Subject: NRC Design Review Questions  
Independent Design Verification Program  
Detroit Edison - Enrico Fermi Unit 2  
Docket #50-341

Enclosed is Cygna's response to the NRC's request for additional information on the Independent Design Verification Program (IDVP) for Detroit Edison's Fermi-2 plant. This information was requested in a letter from Mr. B.J. Youngblood of the NRC to Dr. W. Jens of Detroit Edison and Mr. L. Kammerzell of Cygna Energy Services dated March 27, 1984.

## 8.2.1 ENCLOSURE 1, QUESTIONS 1 AND 2

Figure 8.2.3.2-1  
Reinforcement at Shear Wall to Base Mat Joint

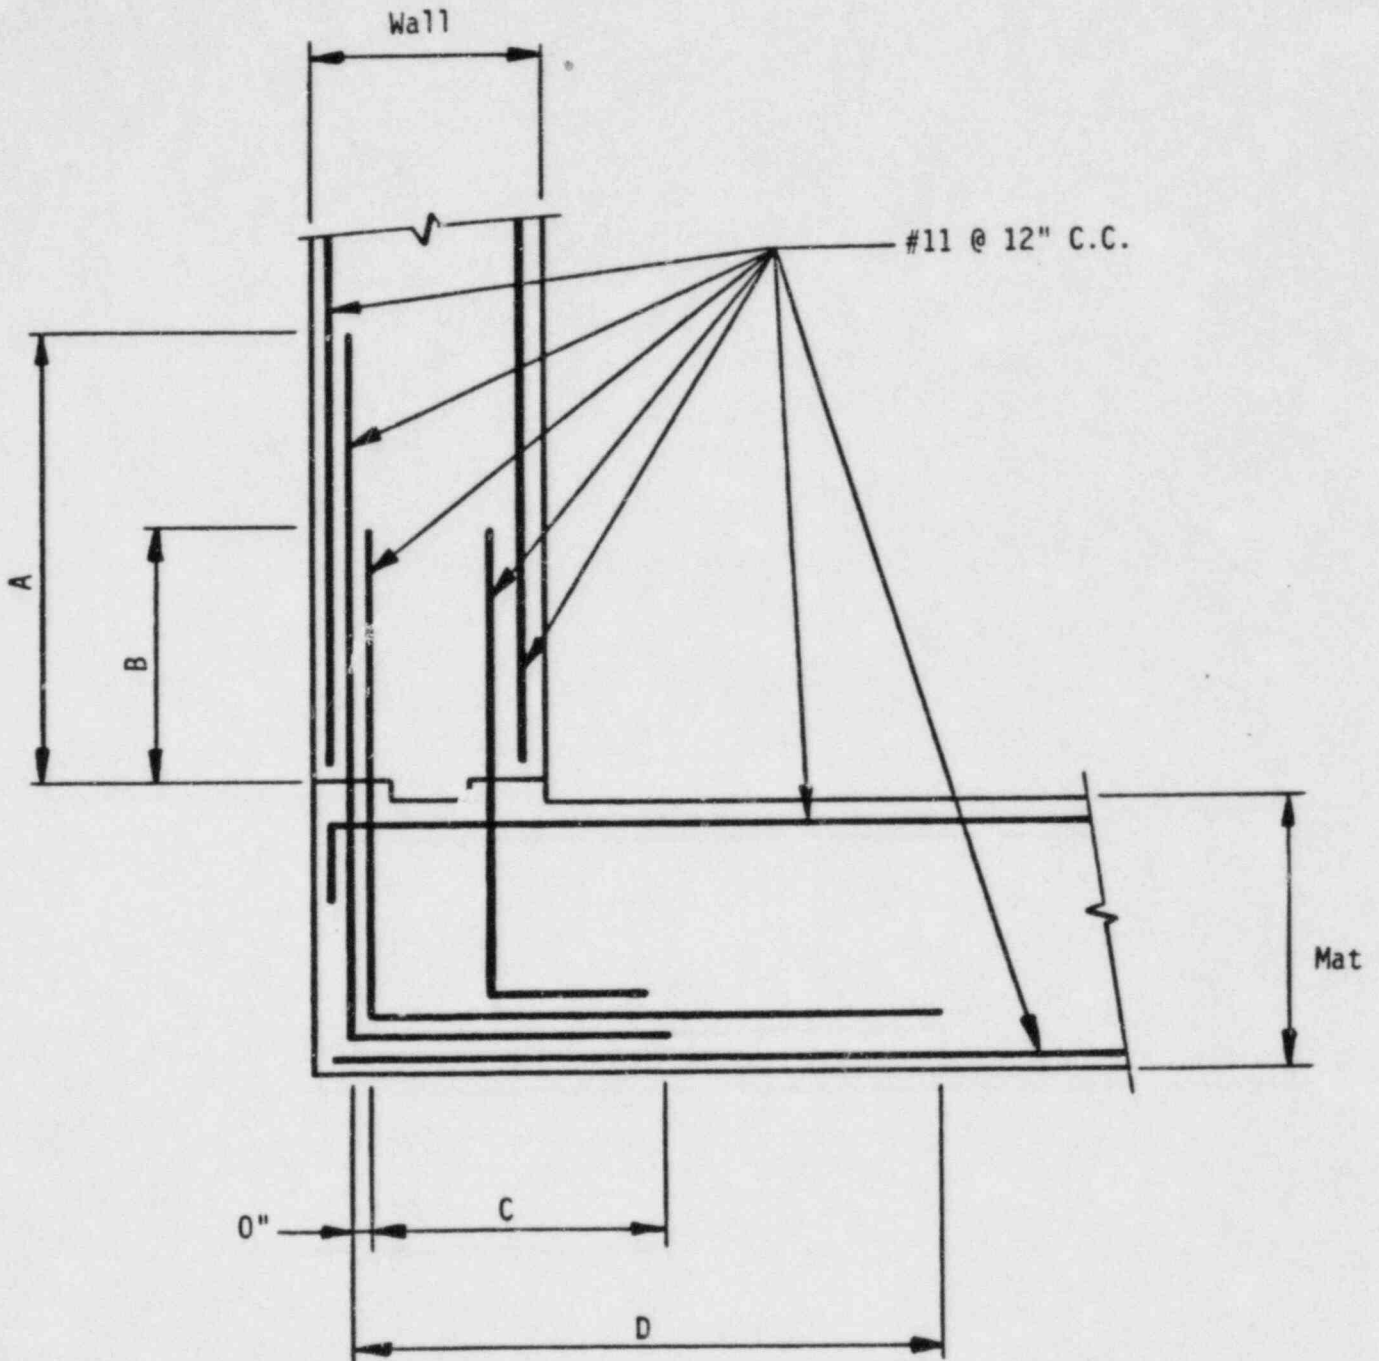
"For Observations ST-01-03, ST-01-06, ST-01-09, ST-01-13 and ST-01-16, Cygna states that the as-built reinforcing steel provides the required structural capacity despite the apparent design deficiency. We request that Detroit Edison instruct Cygna to provide for each of the observations cited above, a simple sketch showing the location of the reinforcing steel bars as designed and as the bars are actually installed at the section for which the steel requirement was computed. Cygna should also indicate the development length of these bars. This addition to Cygna's report should also address the potential generic implication of these apparent design deficiencies on the design adequacy of the other safety-related structures of the Fermi-2 facility since the NRC staff has no assurance that the other safety-related structures will have the same structural margin which was the basis for Cygna's acceptance of the observed structural deficiencies."

Figure 8.2.3.2-1 and Table 8.2.3.2-1 compare reinforcement details for the foundation wall/basemat joint, as specified in the various revisions of the calculation sets and drawings. In Revision 0 of the design calculations, the designers calculated only general reinforcement requirements. Details of the reinforcement were not specified. For more highly loaded regions the following statement was provided in the calculation:

Therefore, as shown in Figure 8.2.3.2-1 and Table 8.2.3.2-1, consistent reinforcement details were used throughout the design process. Figure 8.2.3.2-2 shows these reinforcement details.
